**ISSUE:** Certificate of Appropriateness for new construction

**APPLICANT:** 808 Washington LLC c/o Wire Gill LLP

**LOCATION:** Old & Historic Alexandria District  
802-808 North Washington Street

**STAFF RECOMMENDATION**

**Figure 5: Proposed demolition of a portion of the roof at the rear ell**

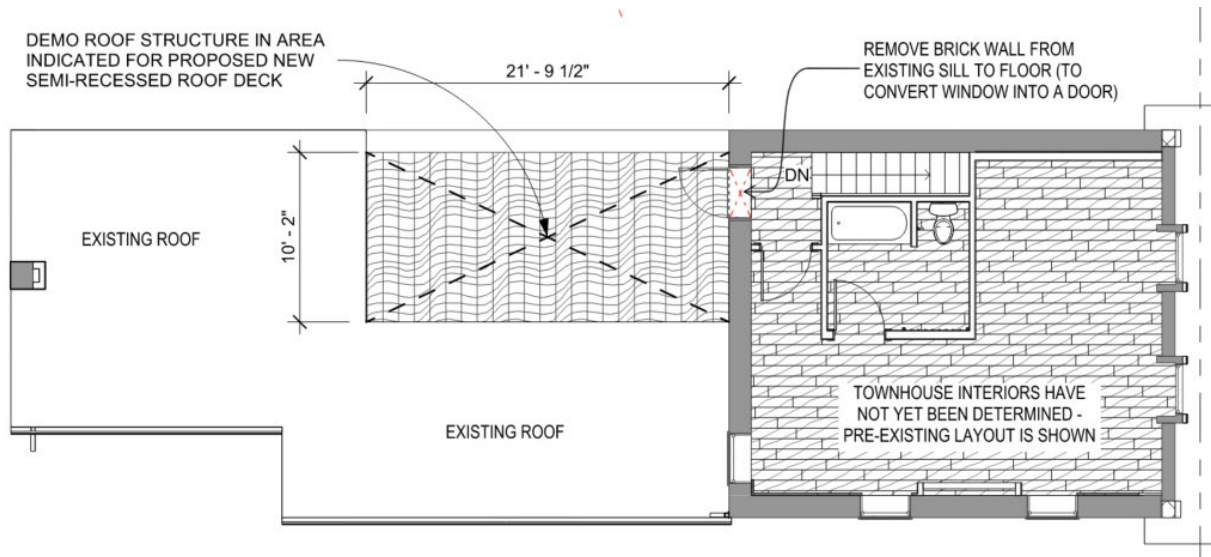
The proposed demolition at the roof of the rear ell of the townhome will allow for the construction of a roof deck in the area. The proposal is to demolish a portion of the roof slope and a portion of the exterior wall under an existing window (Figure 5). This will create a flat surface for the roof deck and a new door providing access to the deck. Staff finds that the extent of demolition is minimal and does not include any unique or uncommon design. The proposed demolition will allow for a roof deck that is minimally visible and with little impact on the historic roof form.

**Figure 6: Axonometric and plan showing modifications to the historic townhome**

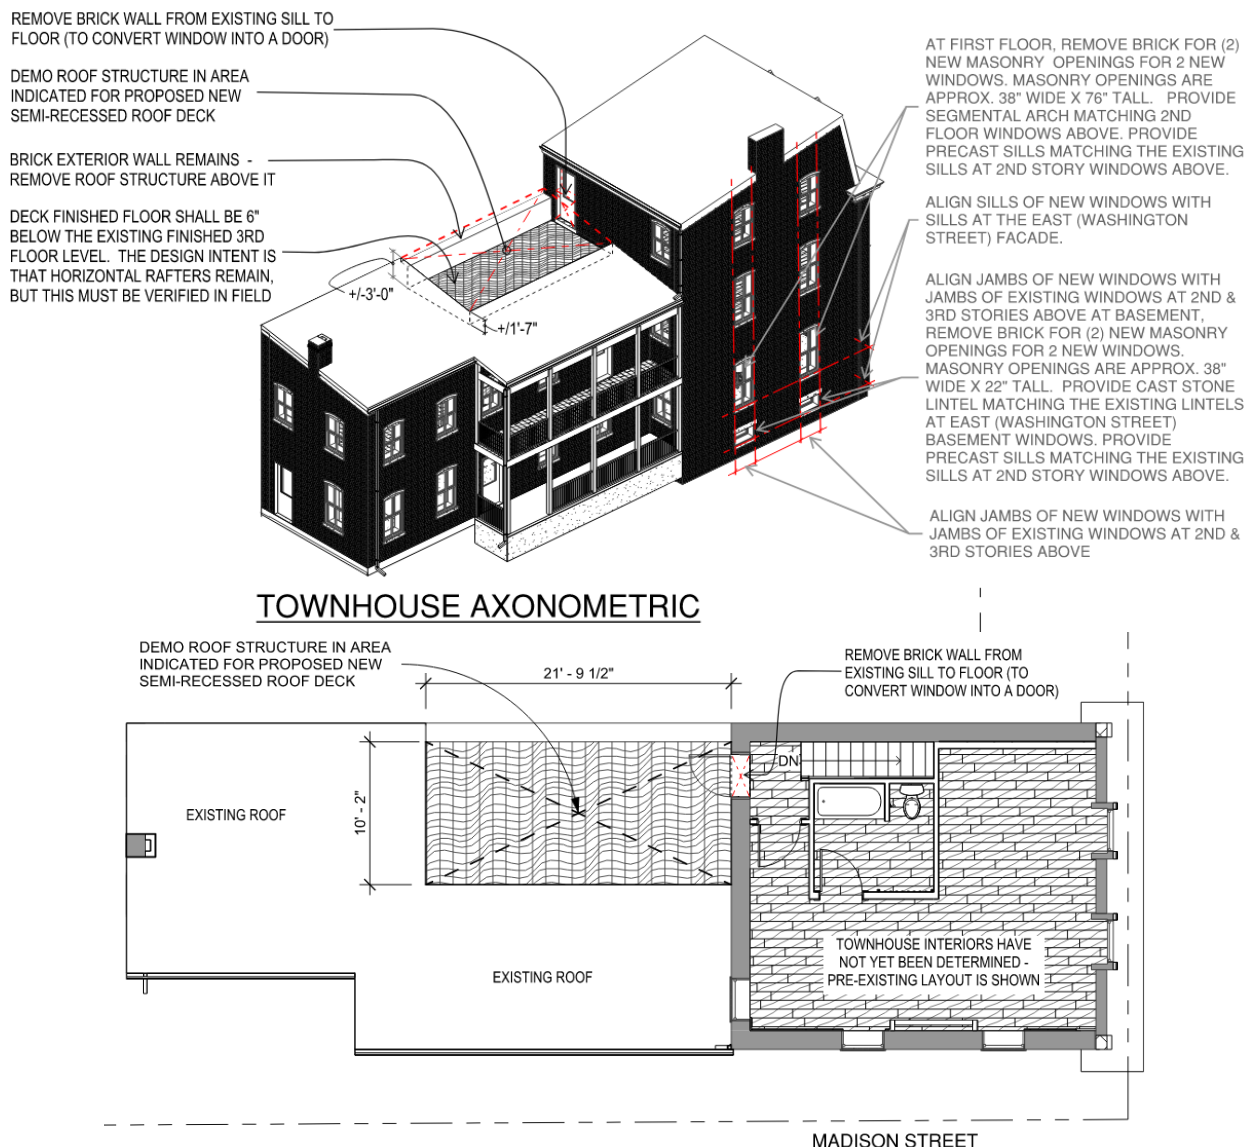
The roof deck will be recessed into the shed roof at the existing ell by removing a portion of the sloping roof area and creating a sunken level area (Figure 6). Access to the roof deck will be through a new exterior door created by enlarging an existing window opening. The perimeter of the roof deck will be enclosed by a glass guard rail. The effect of this configuration is that the roof deck will be unobtrusive when viewed from the street. The *Design Guidelines* state that “Roof decks should be constructed so that they do not interfere with the historic roofline of a building.” By recessing the roof deck into the existing roof form, the historic roof line is retained, expressing the original design intent for the rear ell. Staff finds this approach to be consistent with the *Design Guidelines*.

The applicant is proposing to install four new windows in the south elevation of the historic townhome. This work could not be approved administratively and requires approval by the Board. Per the submission documents, the new windows will be at the basement and first floor on the south elevation and will match similar windows on the building in terms of the masonry openings and the window configuration. This will include the use of segmental arches at the second floor windows and precast heads and sills at the basement windows. Staff supports this proposal and finds that the resulting configuration will be consistent with similar historic structures.

PERSPECTIVE FROM NORTH-NORTHEAST (FROM APPROX 15' ABOVE GRADE)

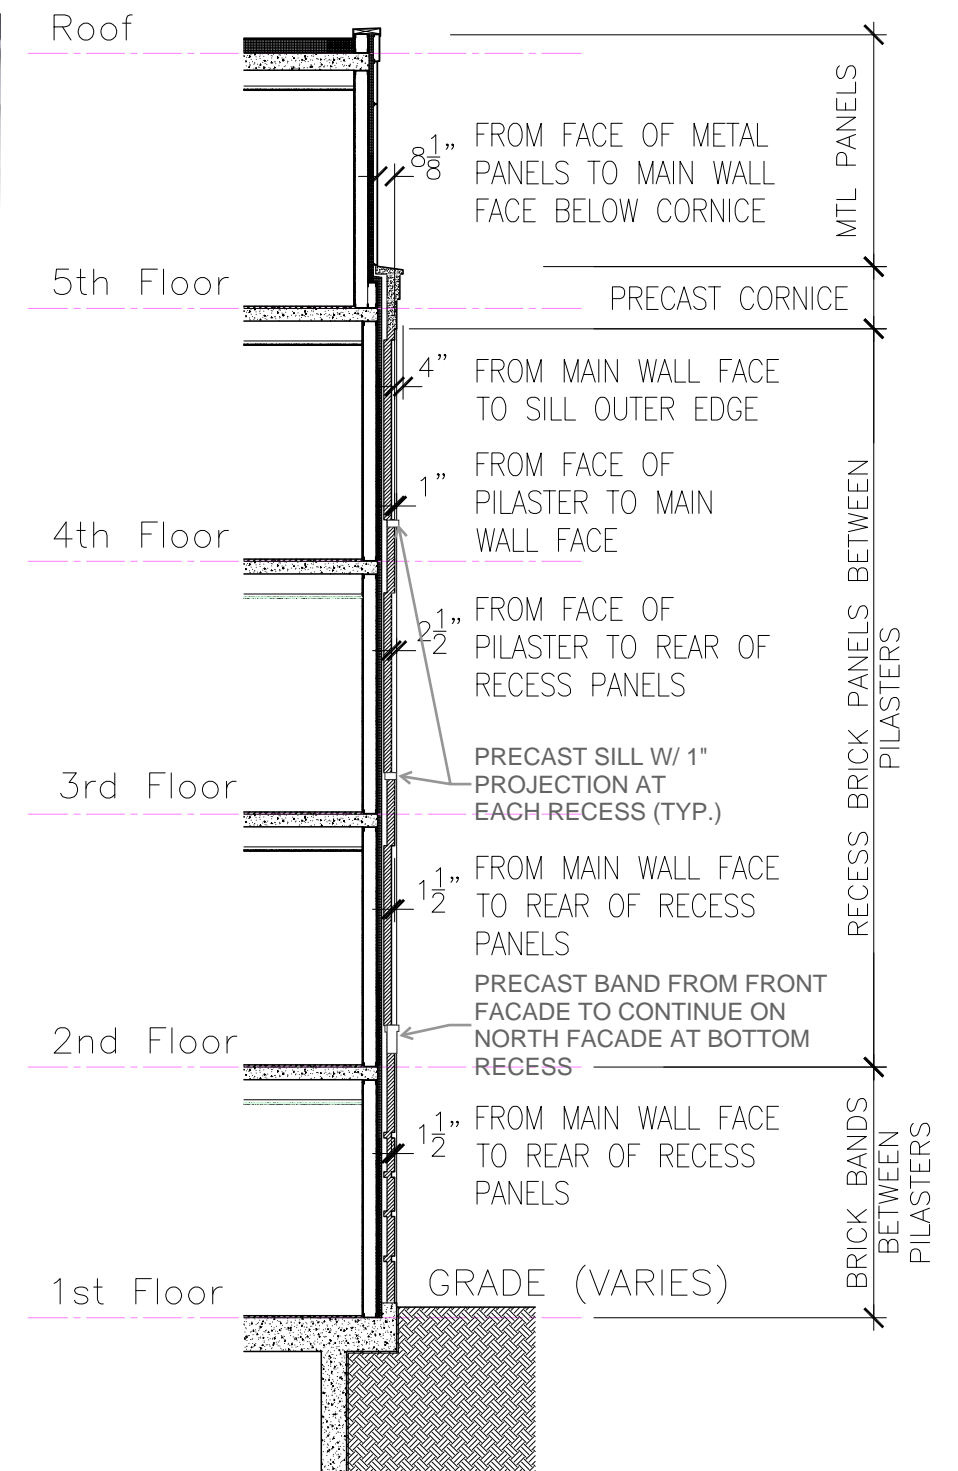
There was some concern expressed by Board members at the last hearing regarding the treatment of the north elevation. This wall is on the property line and does not feature window openings. While there may be a new building on this location in the future, there is currently nothing approved. Board members specifically noted the prominence of this wall as visitors to the historic district arrive from the north on the George Washington Memorial Parkway.

The previous design for this area included a series of square insets with the precast band at the second floor stopping one bay into the elevation. In response to comments from the Board, the applicant has revised the design to include additional articulation on this wall (Figure 4). In the revised design, the square insets are replaced by recesses in the shape and configuration of the punched window openings found on other portions of the building. These recesses use a lighter color brick to further draw a distinction between the two planes and include precast heads and sills. The overall impression is of a wall where existing windows have been infilled over time.

ADDED DETAIL ON NORTH FACADE PICKS UP THE RHYTHM OF THE OVERALL COMPOSITION.

## TOWNHOUSE AXONOMETRIC

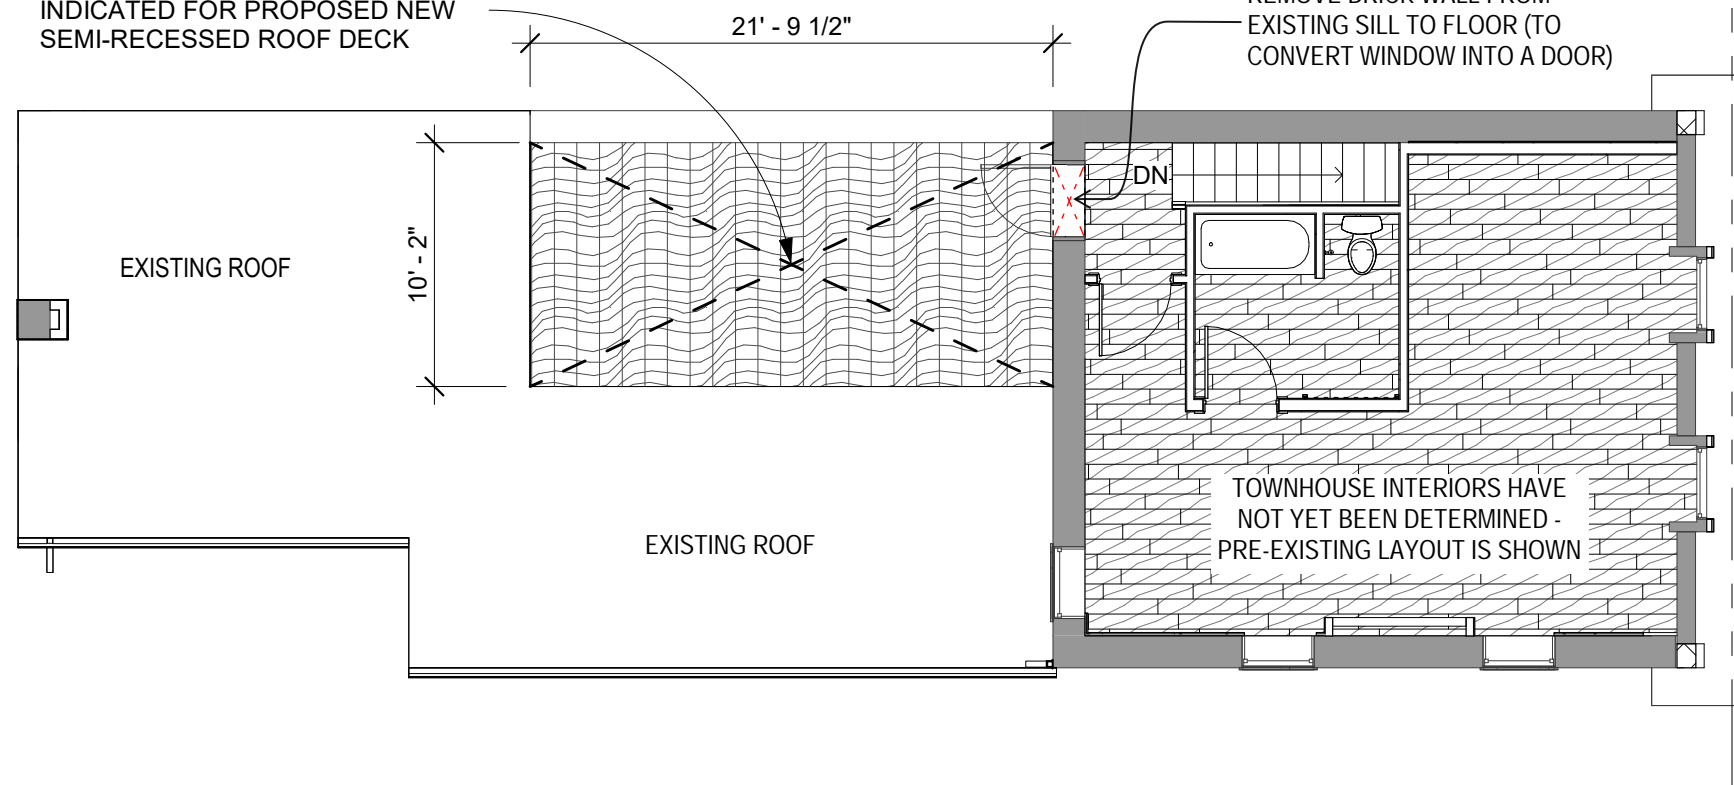
- A new roof deck will be created at the top of the rear ell be demolishing an area of approximately 10’-2” x 21’-9” and recessing the new floor into this area. An existing window will be converted into a door to provide access to this roof deck.

DEMO ROOF STRUCTURE IN AREA INDICATED FOR PROPOSED NEW SEMI-RECESSED ROOF DECK
